# Access Compliance Report

## Public Rights-of-Way

### (Pedestrian Signals)

Intersection ID: N/A	Main Street:	Cross Street: N/A	Location: N/A
ADA ID: F2C1237B824D	Signal Type: One Push Button-Non APS	Overall Compliance: No	Severity Score: BTN 1: N/A BTN 2: N/A No BTN: N/A
Codes/Mitigation Info/Possible Solution		Field Measurements/Component Compliance

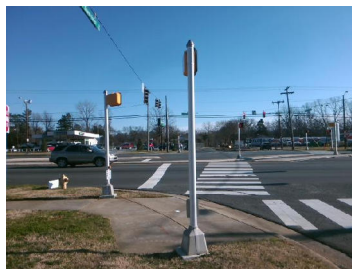
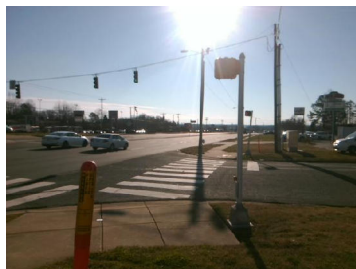
Compliance	Description	Data	Compliance	Description	Data
	Button Count	Button1	Yes	Distant to Additional Button (in)	205.0
	Additional Button Present?	Yes		Additional Button ID	6729E90705EF
N/A	Signal Buttons Required?	N/A	N/A	Additional Ped Posts Required	N/A
	How Many Ped Street Xings?	2		Located In An Island/Median?	No
N/A	B 1 Sign Present?	Yes	N/A	B 2 Sign Present?	N/A
Yes	B 1 Sign Purpose?	Yes	N/A	B 2 Sign Purpose?	N/A
Yes	B 1 Sign Lettering & Contrast?	Yes	N/A	B 2 Sign Lettering & Contrast?	N/A
Yes	B 1 Parallel To XWalk?	Yes	N/A	B 2 Parallel To XWalk?	N/A
Yes	B 1 PAR to Button?	Yes	N/A	B 2 PAR to Button?	N/A
Yes	B 1 PAR to XWalk?	Yes	N/A	B 2 PAR to XWalk?	N/A
Yes	B 1 Clear Floor Space?	Yes	N/A	B 2 Clear Floor Space?	N/A
N/A	B 1 FWD Approach?	Yes	N/A	B 2 FWD Approach?	N/A
N/A	B 1 FWD Approach Constrained?	No	N/A	B 2 FWD Approach Constrained?	N/A
No	B 1 FWD Approach Reach (in)	8.0	N/A	B 2 FWD Approach Reach (in)	N/A

N/A	B 1 FWD Approach Width (in)	N/A	N/A	B 2 FWD Approach Width (in)	N/A
N/A	B 1 FWD Approach Obstruction?	Yes	N/A	B 2 FWD Approach Obstruction?	N/A
N/A	B 1 FWD Approach Obstruction Dist (in)	4.0	N/A	B 2 FWD Approach ObstructionDist (in)	N/A
N/A	B 1 PARA Approach?	Yes	N/A	B 2 PARA Approach?	N/A
N/A	B 1 PARA Approach Constrained?	No	N/A	B 2 PARA Approach Constrained?	N/A
Yes	B 1 PARA Approach Reach (in)	6.0	N/A	B 2 PARA Approach Reach (in)	N/A
N/A	B 1 PARA Approach Width (in)	N/A	N/A	B 2 PARA Approach Width (in)	N/A
N/A	B 1 PARA Approach Obstruction?	Yes	N/A	B 2 PARA Approach Obstruction?	N/A
N/A	B 1 PARA Approach Obstruction Dist (in)	4.0	N/A	B 2 PARA Approach ObstructionDist (in)	N/A
No	B 1 Clear Floor Space Slope (%)	4.3	N/A	B 2 Clear Floor Space Slope (%)	N/A
No	B 1 Clear Floor Space XSlope (%)	3.0	N/A	B 2 Clear Floor Space XSlope (%)	N/A
N/A	B 1 PAR Slope (%)	3.0	N/A	B 2 PAR Slope (%)	N/A
Yes	B 1 Height (in)	39.0	N/A	B 2 Height (in)	N/A

Yes	B 1 Clear Xing Direction?	ClearlyMarked	N/A	B 2 Clear Xing Direction?	N/A
	B 1 Crossing Direction	To SE		B 2 Crossing Direction	N/A
No	B 1 DistanceTo XWalk (in)	72.0	N/A	B 2 DistanceTo XWalk (in)	N/A
No	B 1 DistanceTo Curb (in)	80.0	N/A	B 2 DistanceTo Curb (in)	N/A
Yes	B 1 Diameter (in)	2.0	N/A	B 2 Diameter (in)	N/A

Possible Solutions: Replace Signal Push Button With APS Button on New Post. Remove & Relocate Sign.
